| Designed by RUSHdesign for Solidoodle | | | | |
| IC's, USB, microSD, Endstops, Thermistors | | | | |

Change log

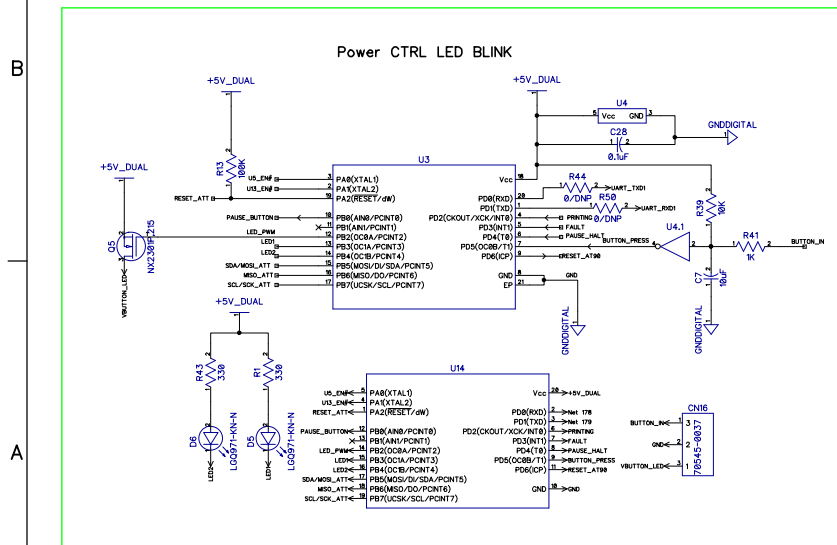
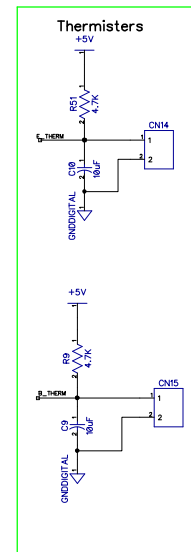
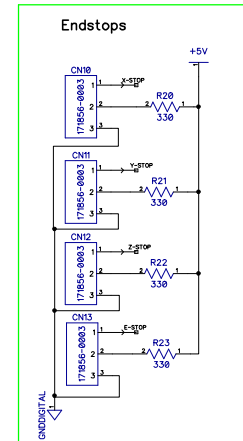
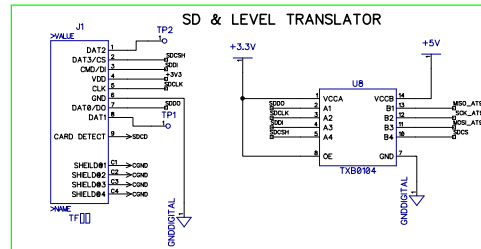
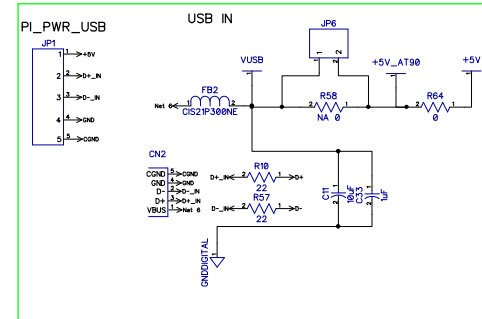
| Issue | Date | Who | Fix Date | comments | Who | Review |
|---|----------|------|----------|--|-----|--------|
| Sense R's Need to Be larger than 0603 | 4/3/2014 | Matt | 4/4/2014 | Switched to 0805 for all controllers | Tom | |
| GND ISSUES AGND AND GND HAVE SAME NAME | | | | Seperated GNDs | | |
| Electrolitic caps missing Values | | | | Matched all to 100uF | | |
| Need to review fet function Sim shows High loss | | | | | | |
| No current limit on Stop Headers | | | | Added 220 current limiter | | |
